**CITY OF MERIDIAN
FINDINGS OF FACT, CONCLUSIONS OF LAW
AND DECISION & ORDER**

Case No(s). H-2020-0124

STAFF REPORT

SUBJECT: H-2020-0124
Ambles Run Subdivision

C. Landscape Plans (date: 12/18/2020) NOT APPROVED

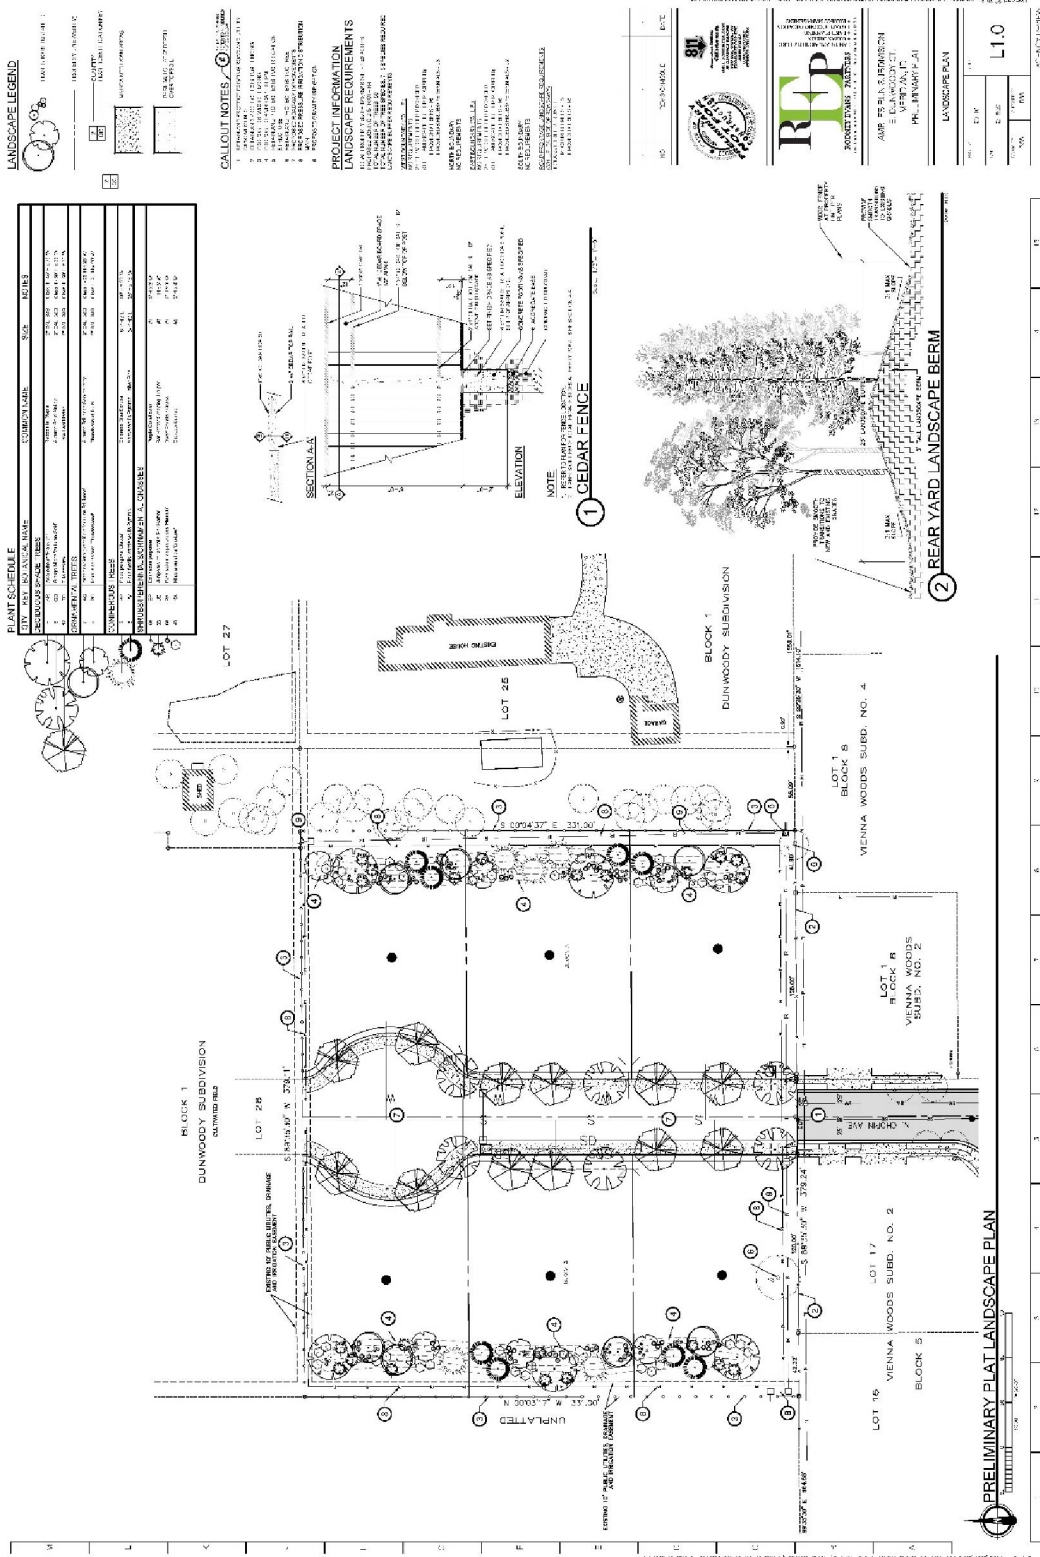
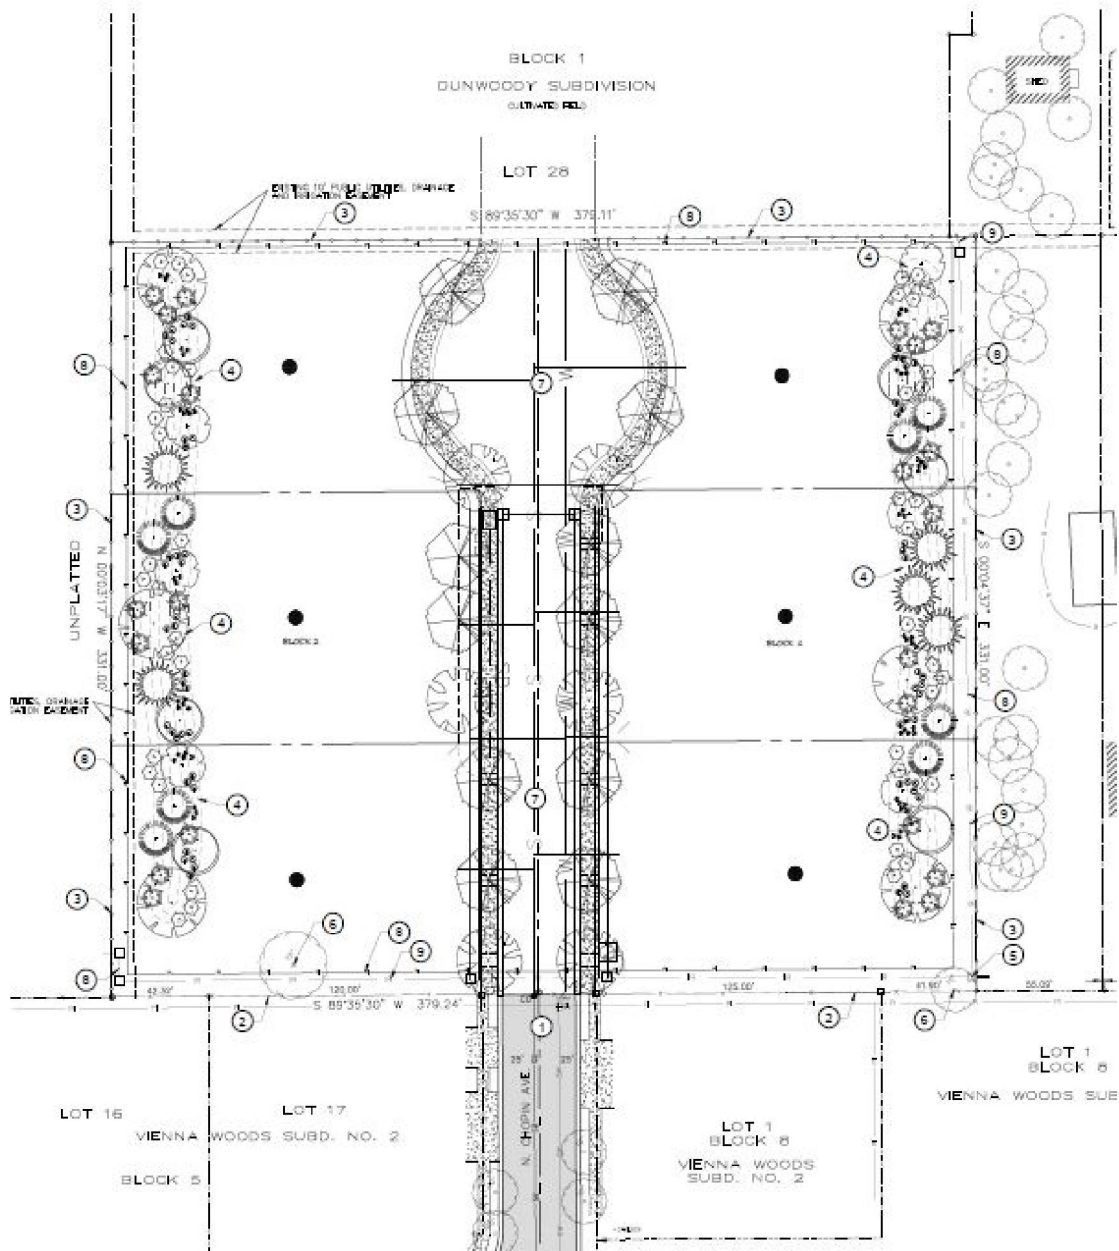
Staff is recommending the proposed parkways be widened to 10' to increase the amount of open space for the small development even though there is not a requirement to meet any minimum open space standard. As discussed within the Comprehensive Plan analysis section earlier, increasing the width of the parkways allows the project to provide at least 5% open space which helps meet the intent of the code and comply with the comprehensive plan. In addition, the wider parkway would allow for healthier trees and provide the Applicant the opportunity to use a wider range of trees within the parkways, including larger Class III trees if so desired. Staff recommends constructing the recommended western stub street with 8-foot parkway on its southern side to match what is currently proposed. This parkway should also be landscaped in accord with UDC standards.

- b. Revise the plat to show 10-foot wide parkways with 5-foot wide detached sidewalks consistent with UDC 11-3A-17 and Staff's recommended changes.
3. The landscape plan included in Section VII.D, dated November 18, 2020, shall be revised as follows ~~at least ten (10) days prior to the City Council hearing with the final plat submittal:~~

- a. ~~Revise the plan to show the revised plat layout per conditions above.~~
 - b. Revise the plan to show 10-foot wide parkways.
4. Future development shall be consistent with the minimum dimensional standards listed in UDC Table 11-2A-4 for the R-2 zoning district.
